Access Compliance Report

Public Rights-of-Way

(Curb Ramps)

Intersection ID: 3544	Main Street: VOLUSIA_CT	Cross Street: WEAVERS_GLENN_PL	Location:	S
ADA ID: 45CE33BE21D9	Ramp Type: PerpDiag	Initial Pass/Fail: Fail	Overall Compliance: No	Severity Score: 10
Codes/Mitigation Info/Possible Solution		Field Measurements/Component Compliance

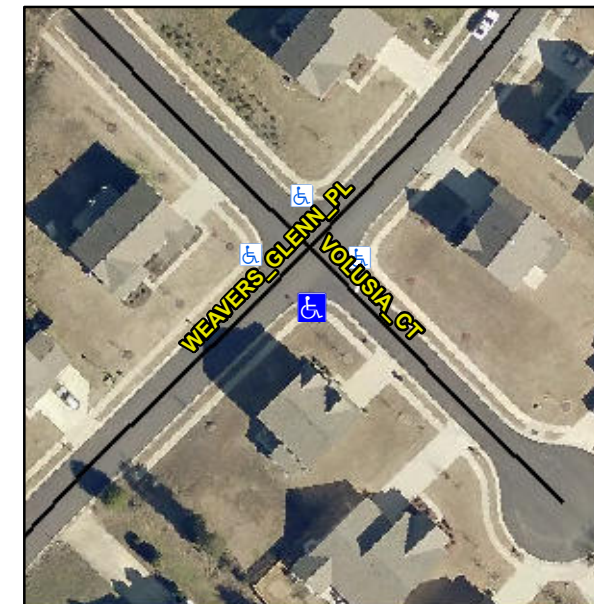
PROW/ADA:

Not Found, R304.5.1, R304.5.3

Compliance	Description	Data	Compliance	Description	Data
N/A	Ramp Length (in)	49.0	Yes	Ramp Slope (%)	5.1
No	Ramp Width (in)	40.0	No	Ramp XSlope (%)	4.9
N/A	Flare Type LT	N/A	N/A	Flare Type RT	N/A
N/A	Flare Slope LT (%)	N/A	N/A	Flare Slope RT (%)	N/A
N/A	Flare Traversable LT?	N/A	N/A	Flare Traversable RT?	N/A
N/A	Landing Length (in)	N/A	N/A	DWS Provided?	N/A
N/A	Landing Width (in)	N/A	N/A	DWS Contrast?	N/A
N/A	Landing Slope (%)	N/A	N/A	DWS Length (in)	N/A
N/A	Landing X Slope (%)	N/A	N/A	DWS Full Width?	N/A
N/A	Landing Curb? (Y/N)	N/A	N/A	DWS Offset (in)	N/A
N/A	Shared Landing?	N/A			
N/A	Gutter Ponding?	N/A	N/A	Gutter Slope (%)	N/A
N/A	Gutter Lip Ht (in)	N/A	N/A	Gutter X Slope (%)	N/A
N/A	Painted X Walk1?	No	N/A	Painted X Walk2?	No
	X Walk 1 Direction	To NE		X Walk 2 Direction	To NW
N/A	X Walk 1 Width (in)	N/A	N/A	X Walk 2 Width (in)	N/A
	X Walk 1 Slope (%)	11.7		X Walk 2 Slope (%)	4.9
	X Walk 1 X Slope (%)	2.2		X Walk 2 X Slope (%)	9.2

N/A	Ramp inside XWalk1?	N/A	N/A	Ramp inside XWalk2?	N/A
	Road Slope (%)	5.8	N/A	Clear Space?	N/A
	Road X Slope (%)	9.6	N/A	Clear Space to XWalk (in)	N/A
N/A	Any Obstructions?	N/A	N/A	Storm Grate/Utility Hazard?	N/A
	Obstruction Type			Storm Grate/Utility Type	
		N/A			N/A
			Yes	Surface Condition? (G/P)	Good

Possible Solutions:

Remove & Replace Curb Ramp With Two New Directional Ramps or Equivalent.
